**HISTORIC PRESERVATION COMMISSION STAFF REPORT**

<b>Address:</b>	5808 Warwick Place, Chevy Chase	<b>Meeting Date:</b>	02/23/05
<b>Applicant:</b>	Bonnie Thomson/Eugene Tillman (Gregory Wiedemann, Architect)	<b>Report Date:</b>	02/15/05
<b>Resource:</b>	Contributing Resource Somerset Historic District	<b>Public Notice:</b>	02/09/05
<b>Review:</b>	Preliminary	<b>Tax Credit:</b>	Partial
<b>Case Number:</b>	N/A	<b>Staff:</b>	Tania Tully
<b>PROPOSAL:</b>	Rear addition & landscaping	<b>RECOMMENDATION:</b>	Obtain approval from the Town of Somerset then proceed with HAWP

## HISTORIC AREA WORK PERMIT APPLICATION

For additions and renovation of 5808 Warwick Place, Chevy Chase, Maryland

2 PROPOSED SITE PLAN  
C.O.1 SCALE: 1/16" = 1'-0"

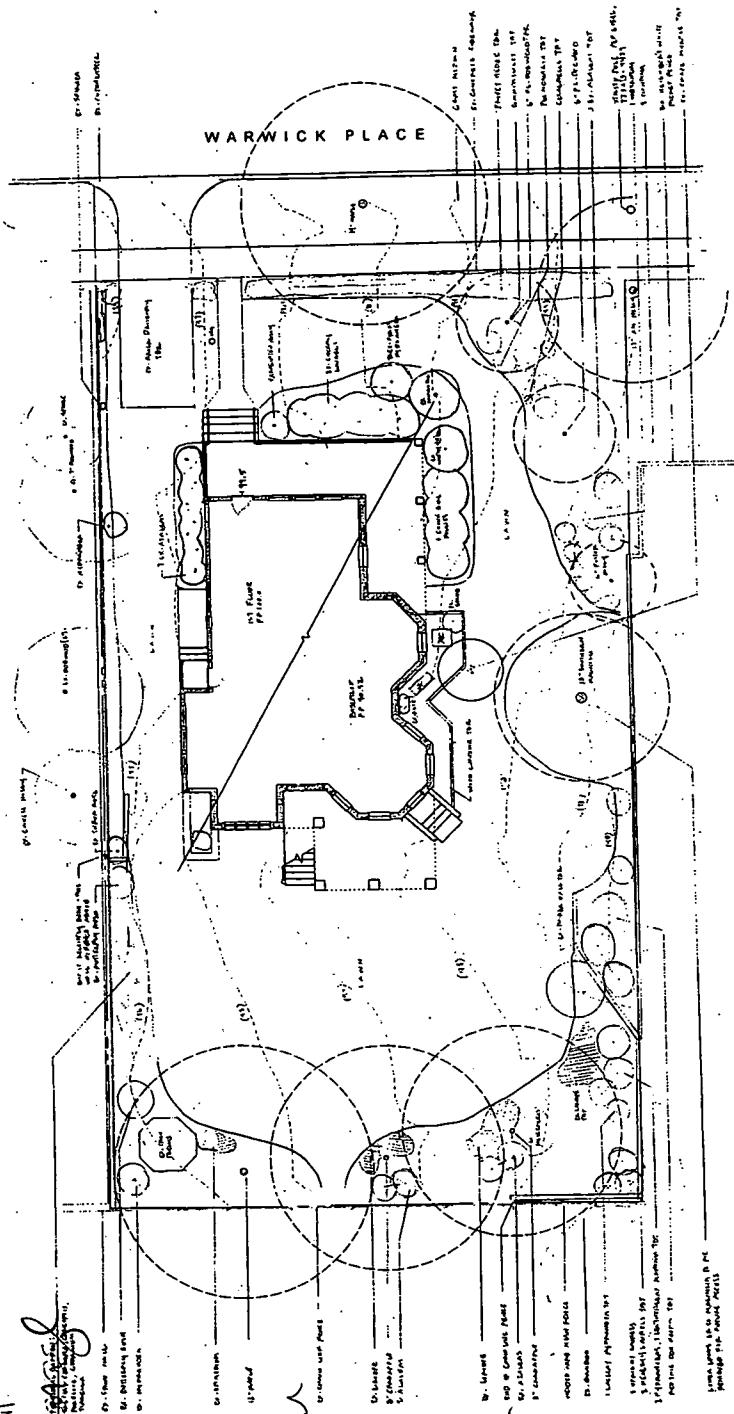
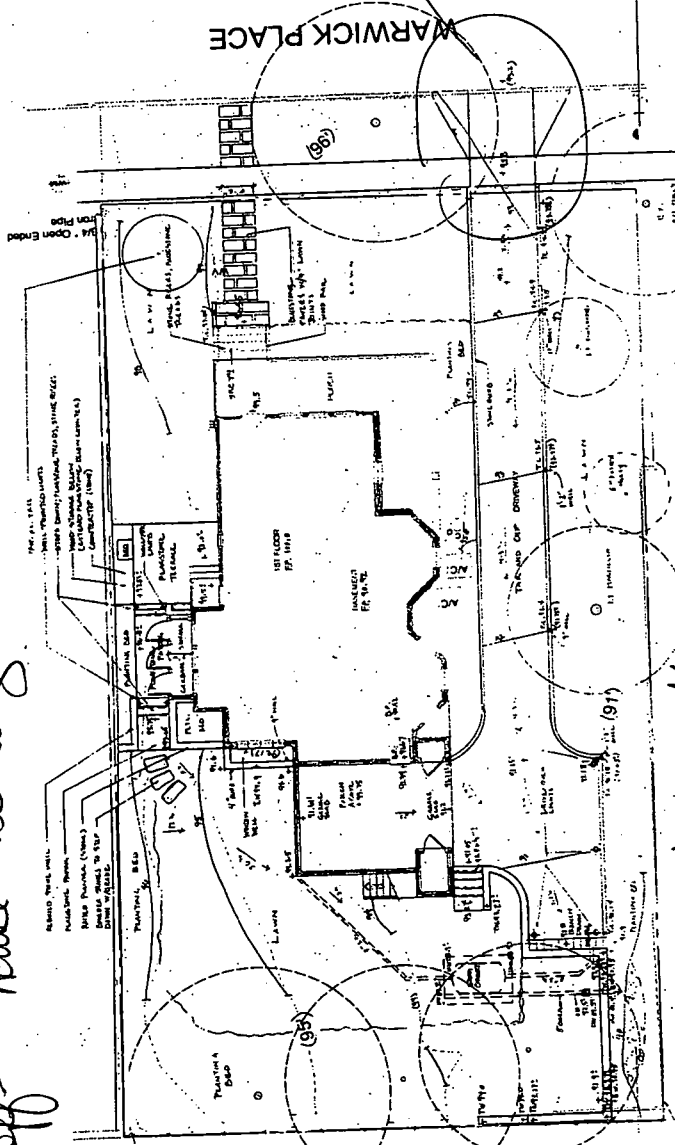
Jeff  
Cardno  
Murray  
Lee  
him  
as opposed  
ok w/ garage

Size Addition OK  
call but off + when

Julia - offer state  
Suggests different  
windows  
I'll talk this  
2/2

Caroline - ok w/ addition - issue of visible paving - less even  
 Julia - problem w/ paving - brown stone chip  
 Lyne - a lot of paving - Magnolia concern - loss of even pad  
 Kim - curb cut, even pad b/w houses  
 Jeff - house too long? see 5 elev

they have neighbor ok w/ curb cut

Kim - addition ok  
 loc. of garage is the issue, eliminate it + problems describe  
 Jeff - ? of grade well done addition reduce length better driveway concerns some what  
 Bartlett - arboreal  
 Tim Zaztra  
 comparatory paving

1  
EX.3  
EXISTING SOUTH ELEVATION  
SCALE: 1/8" = 1'-0"

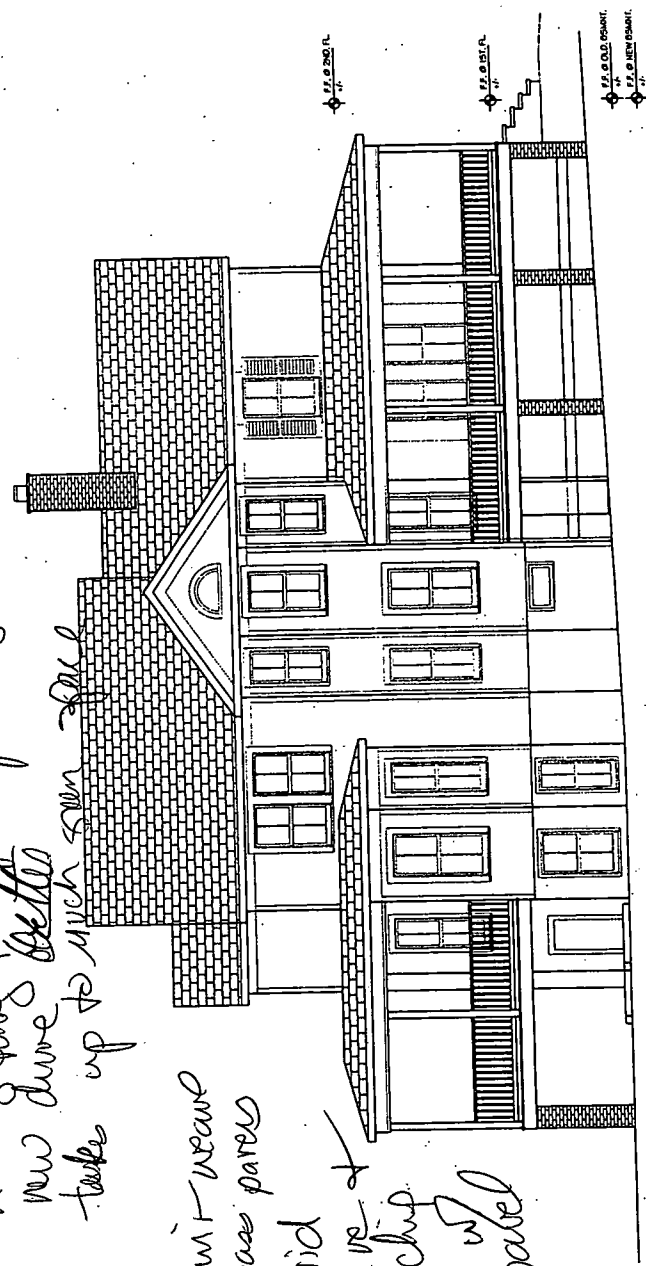
Noray - removing part pad from front yard  
new drive settles  
takes up to much sun fall

Alderson - semi-weave  
grass pavers  
hybrid  
open weave &  
tan + chip  
grass cutte w/  
brown gravel
